SUNDRY NOTICE AND REPORTS ON WELLS

## PLUG AND ABANDONMENT PROCEDURE

### Rosa Unit #59

## **• Conditions of Approval: Proposed P&A**

## Proposed P&A

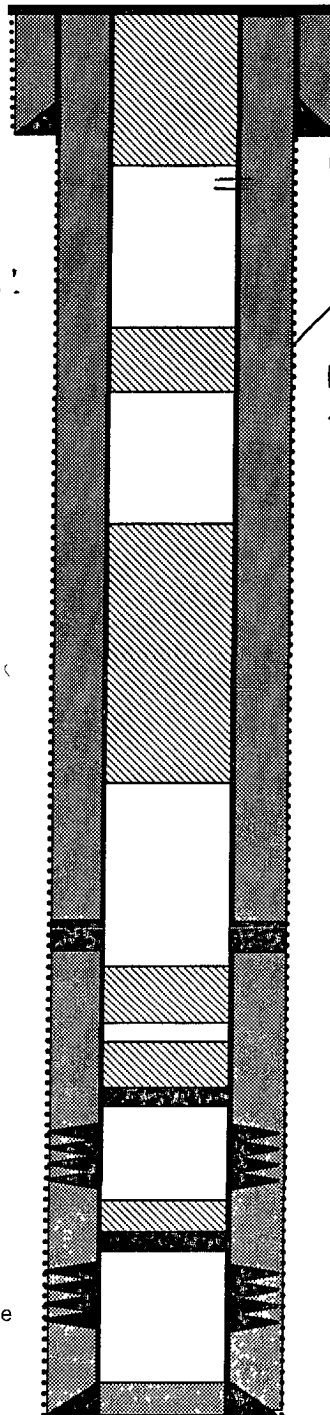
**BLM's Geologist formation top picks vary slightly from the Operators. The following modifications are made to your plug and abandonment program to address these variations and also to include a modified surface casing shoe plug (records indicate a top of cement by temperature survey at +/- 1200' on the 4 ½" production casing string).**

- 1) Plug #3, Due to off-setting gas production in the Chacra Equivalent sands, your proposed Mesaverde plug must be moved up to 4211' – 4111'. This will satisfy isolation of the Mesaverde.
- 2) Plug #4, must be extended from 3256' – 2414' to cover the top of the Ojo Alamo (@ 2464'). An estimated 66 sxs of cement will be required for this plug extension.
- 3) Plug #5, must be spotted from 1221' – 1121' to cover the Nacimiento formation top (@ 1171').
- 4) Plug #6, BLM records indicate that the TOC behind the 4 ½" casing string is 1200' based on a temperature survey. As such, perforate the 4 ½" casing at 467' and spot cement inside and outside to a minimum depth of 367'. Spot cement inside and outside the 4 ½" casing from 50' to the surface. Note: these plugs may be combined if circulation to surface is established

1221' - 1121'  
Plug #5: 1366' - 1266'  
Class B cement, 12 sxs

2414'  
Plug #4: 3256' - 2322'  
Class B cement, 60 sxs  
66

4211' - 4111'  
Plug #3: 5450' - 5350'  
Class B cement, 12 sxs
